Re: **Application #2021-035 – 1 Guion Lane**

**Site Plan, Steep Slope and Tree Removal Permit Approvals**

To follow are our revisions/responses to Kellard Sessions Consulting comments received that were dated 09/23/2021.

To follow are our revisions/responses to Town of North Castle Planning Board comments received that were dated 09/23/2021.

SCALE: 1"=40'	
DATE: DECEMBER 20, 2021	
DRAWN BY: GCGC	CHECKED BY: ES ES
DWG NO.	
SS-1	
SHEET 1 OF 5

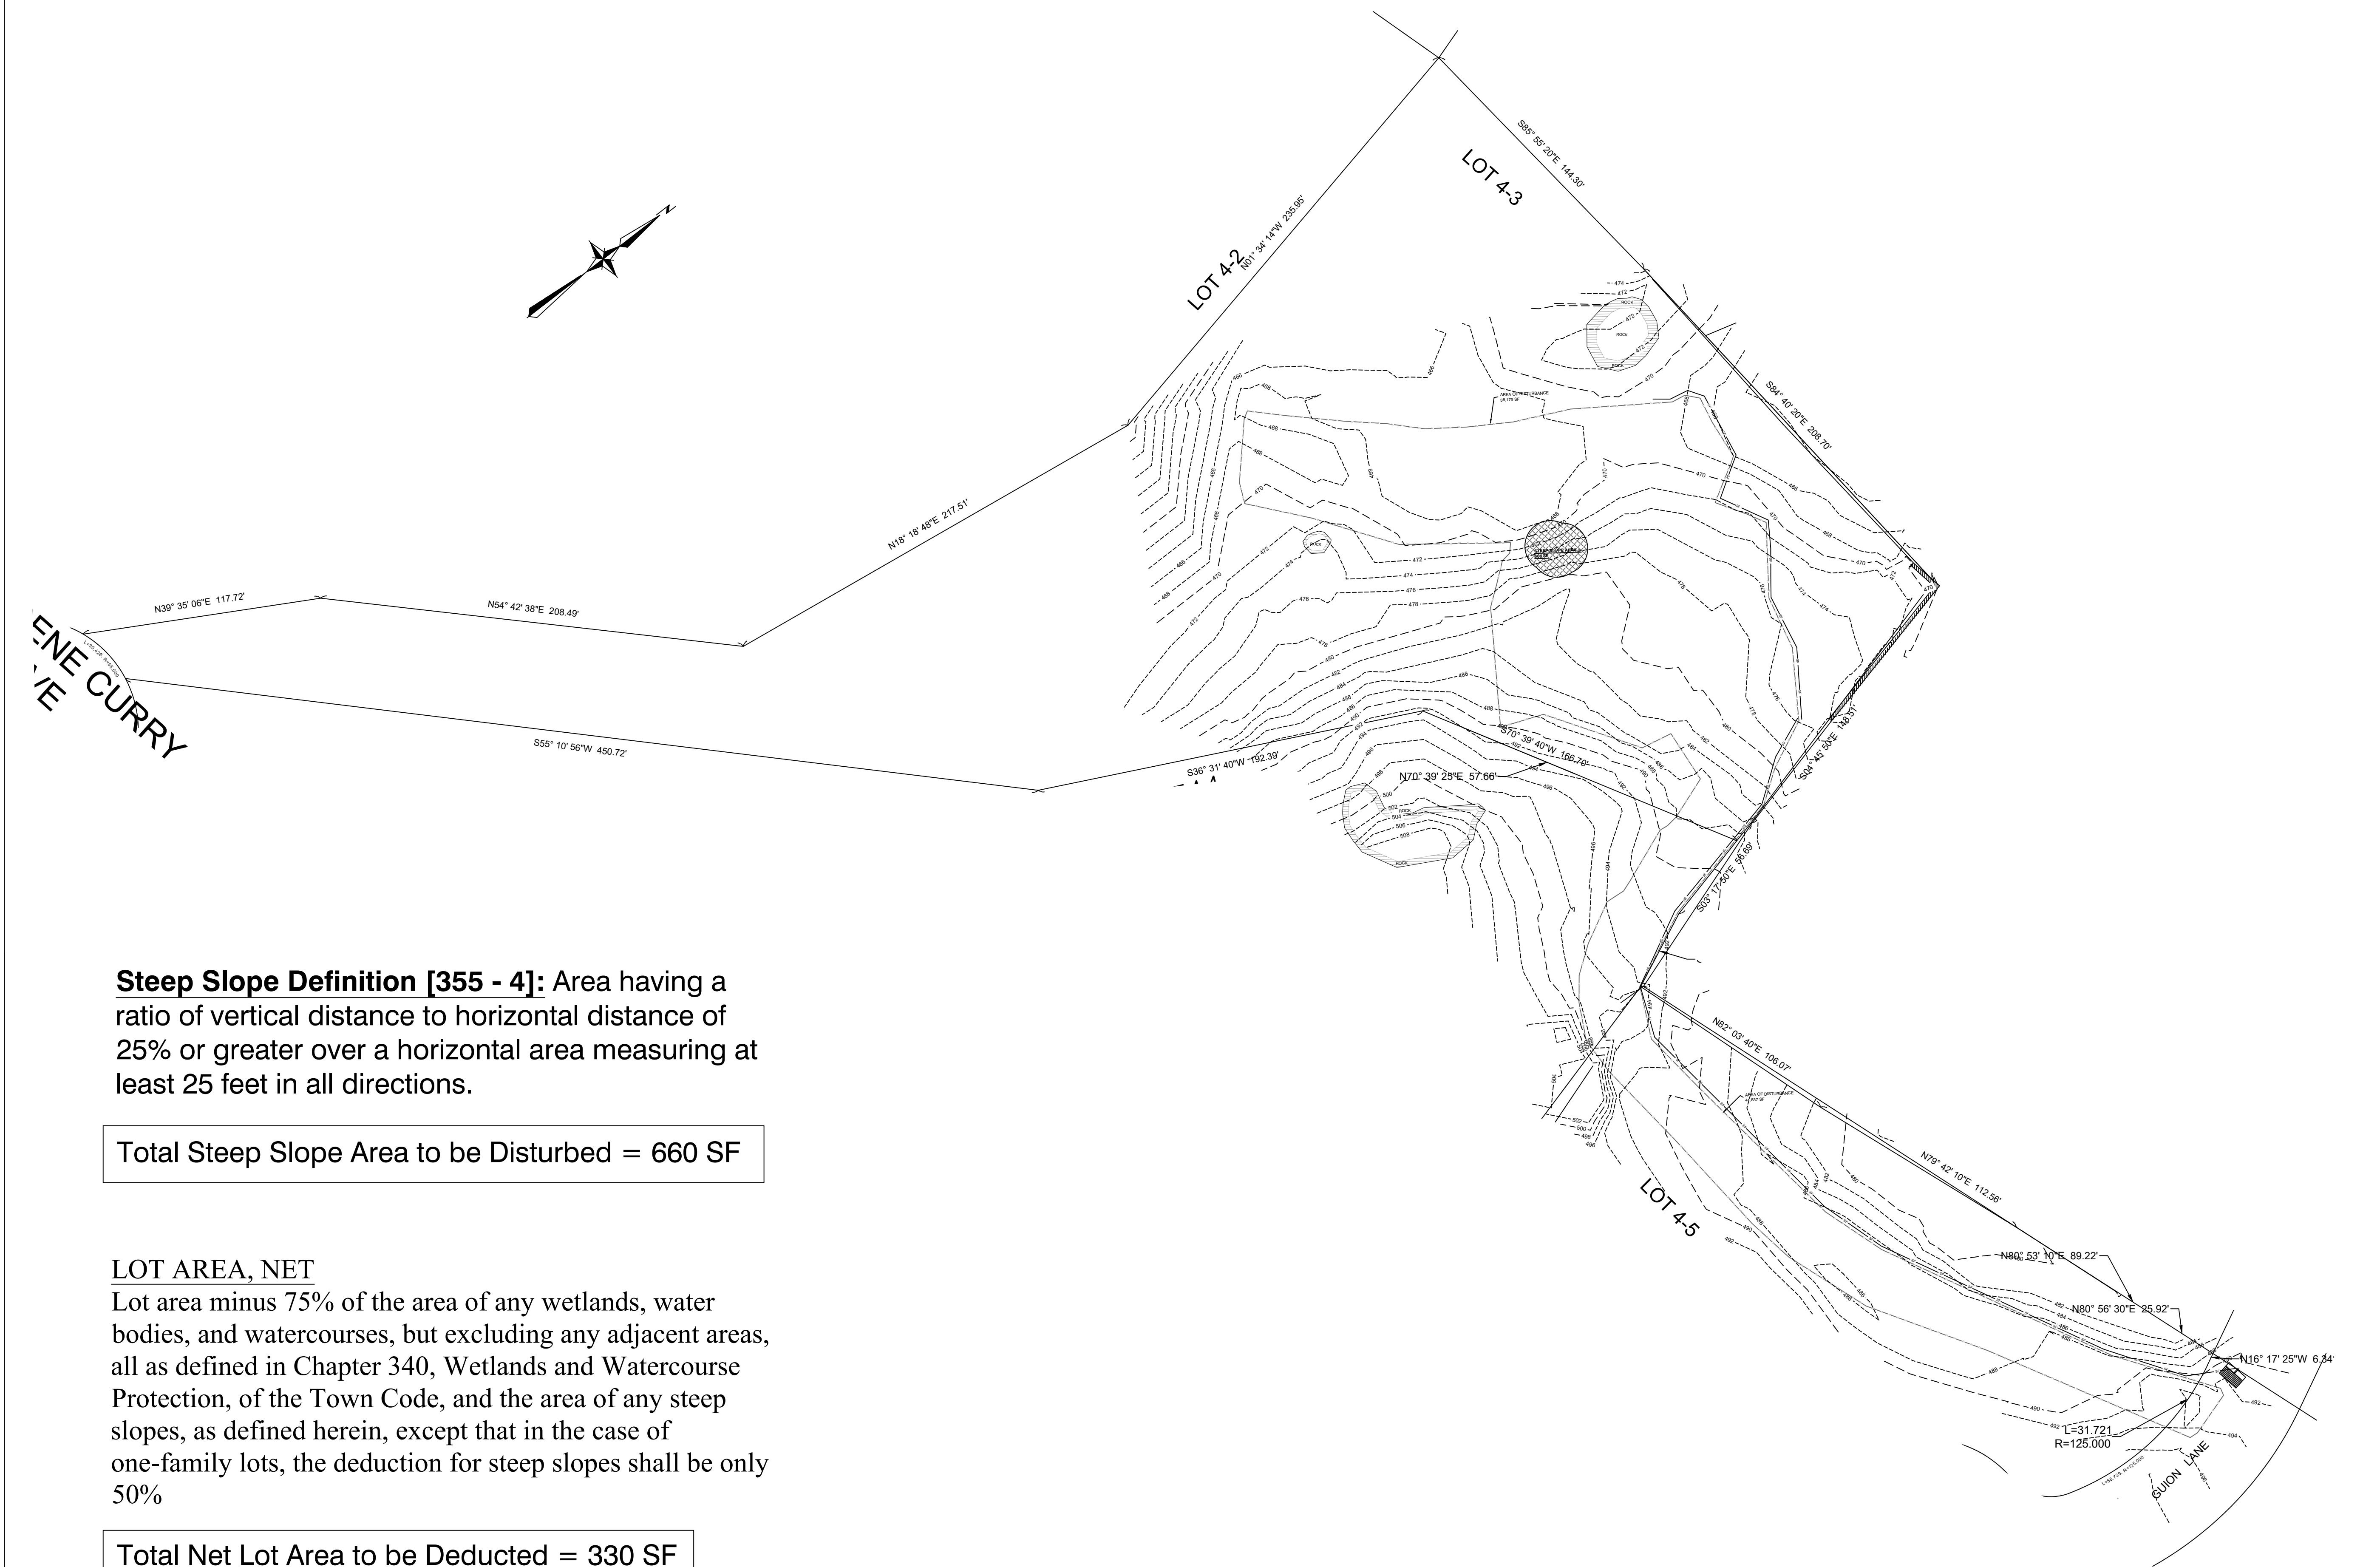
1. The lot appears to contain a significant amount of Town-regulated steep slopes. The Applicant should submit a steep slope exhibit and indicate whether any disturbance to Town-regulated steep slopes is proposed. If so, the Planning Board will need to issue a steep slope permit for this project.

- Sheet SS-1, Steep Slope Analysis is now included as part of the submittal

## PLANTING PLAN

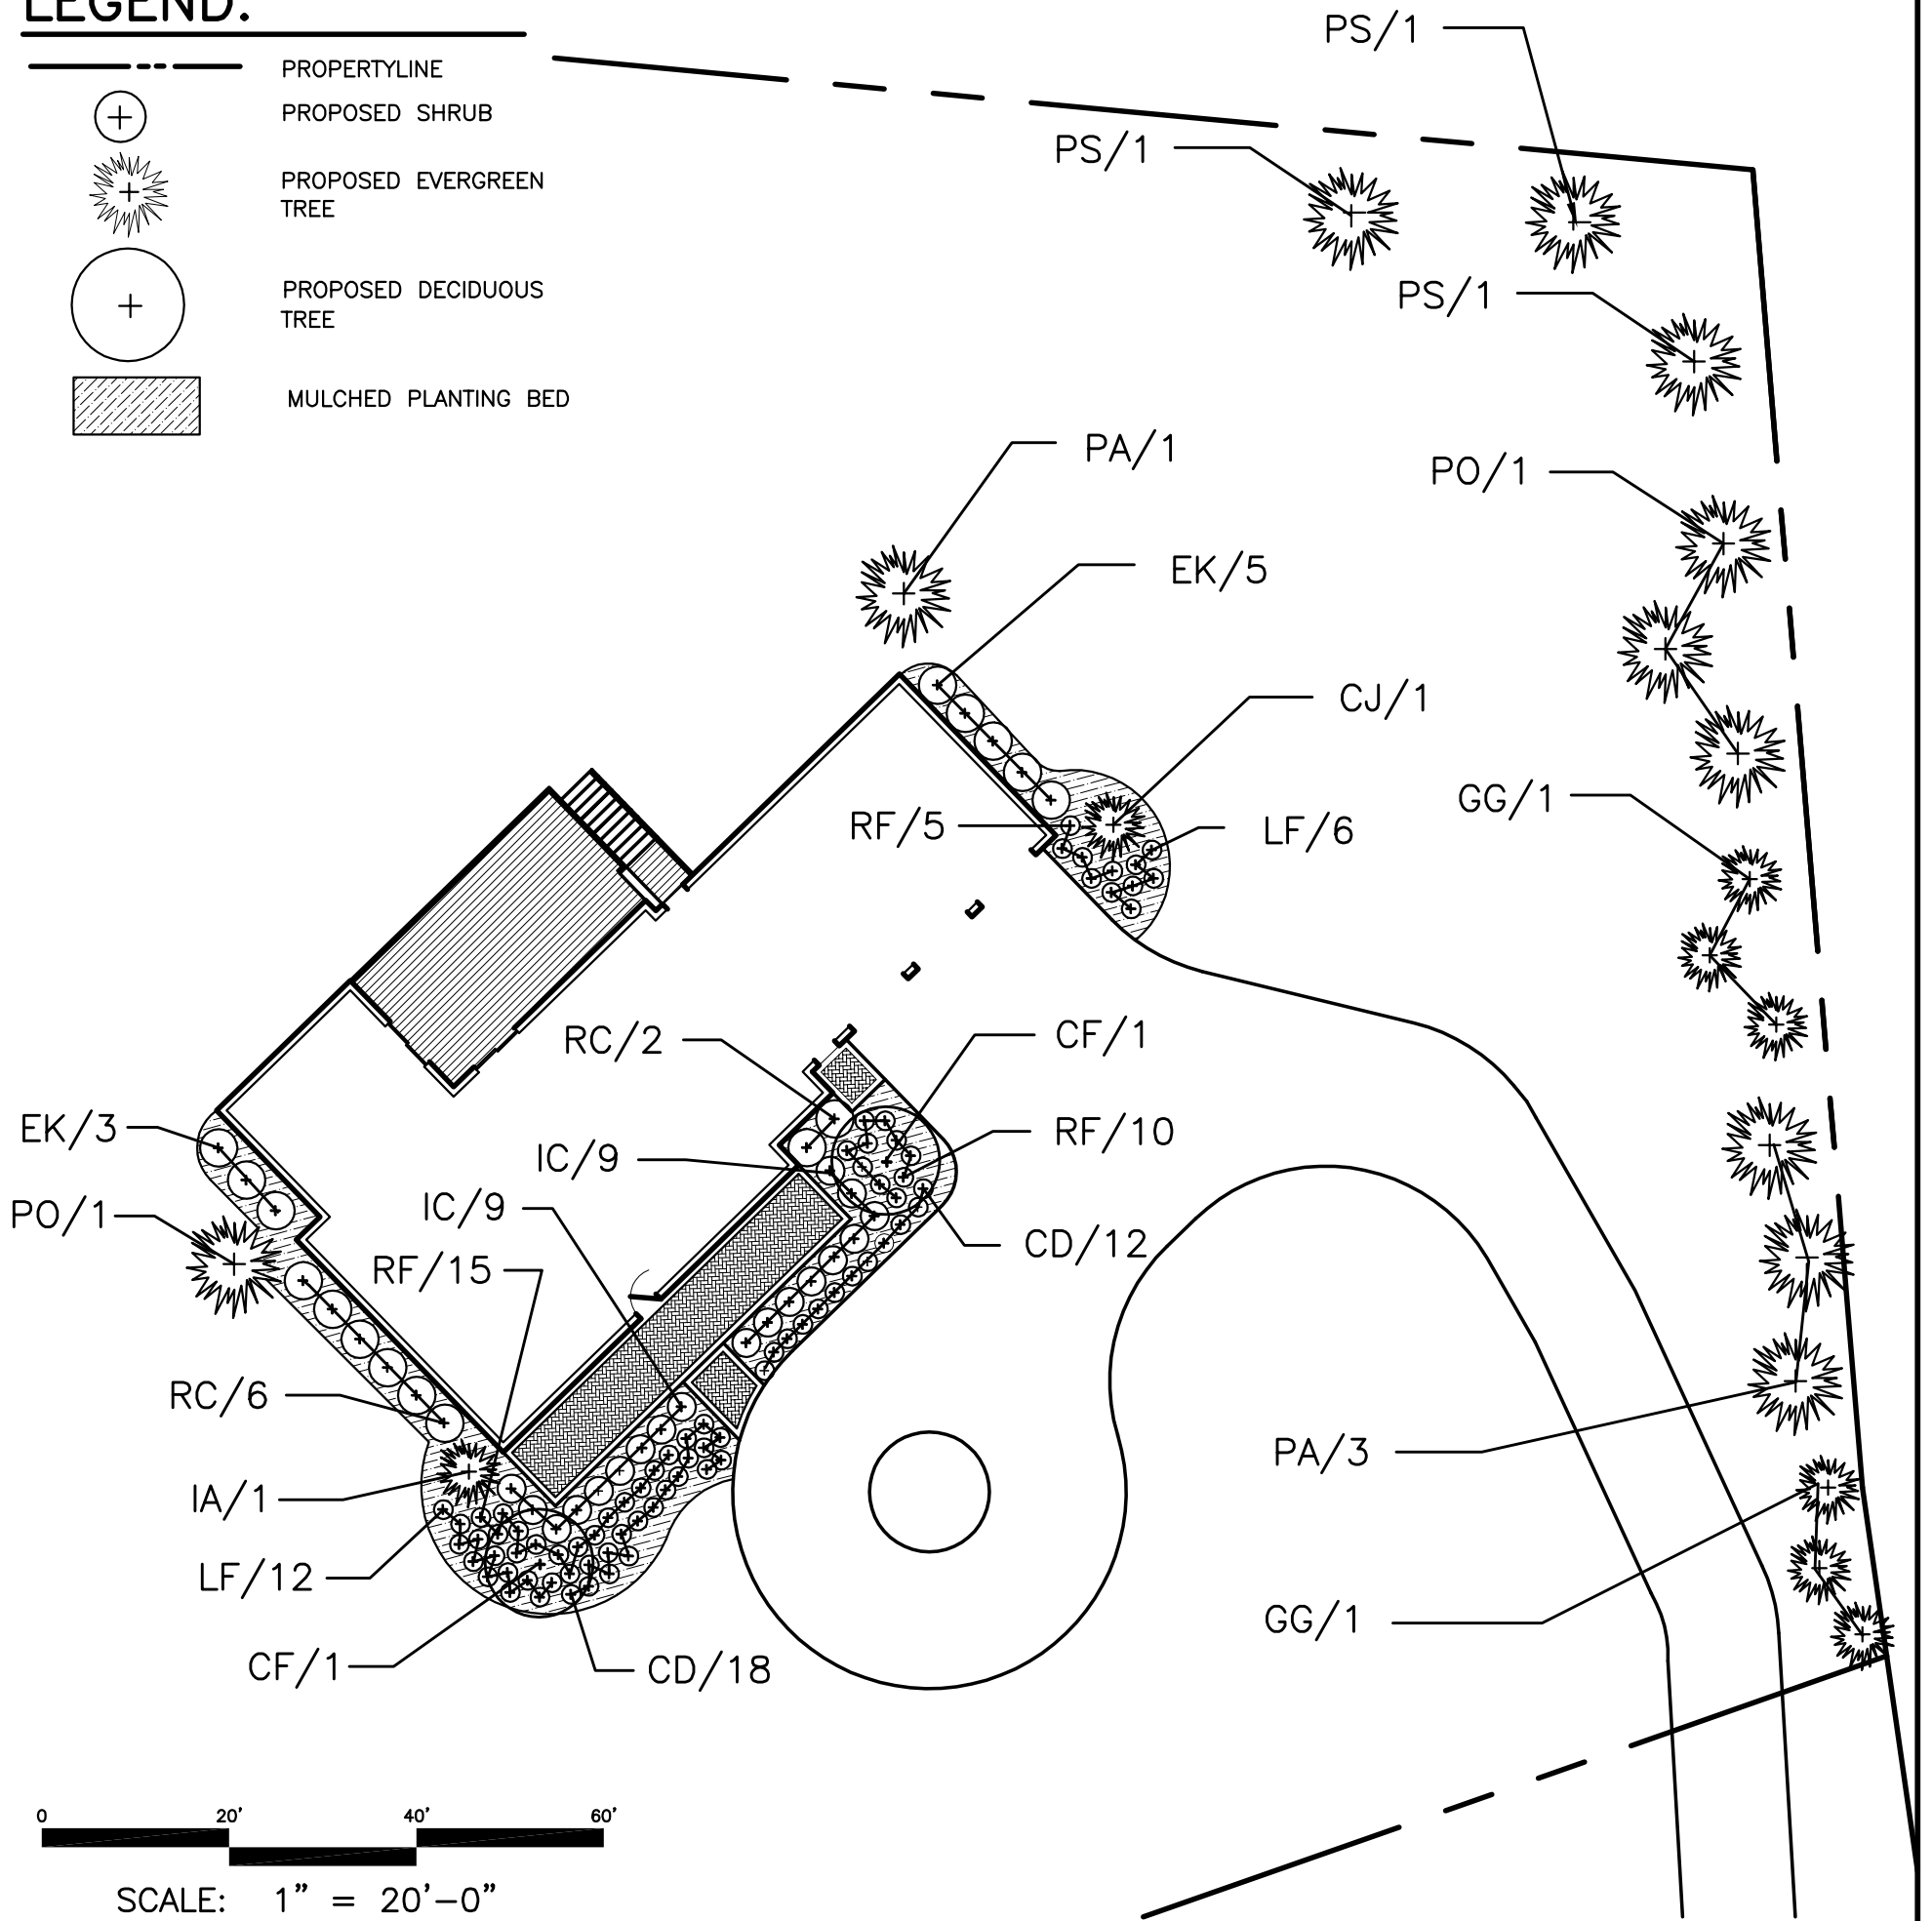
2. It is recommended that adequate screening be proposed along the common drive on 5 Guion Lane.

4. Pursuant to Section 308-13.A(11) of the Town Code, the Applicant should prepare a tree removal mitigation plan detailing the replacement trees proposed to mitigate impacts from the proposed tree removal.

5. The Applicant should submit a proposed landscape plan for review.

- Sheet LS-1, Landscaping / Screening Plan is now included as part of the submittal

- Sheet LS-1, Landscaping / Screening Plan is now included as part of the submittal.

- Sheet LS-1, Landscaping / Screening Plan is now included as part of the submittal.
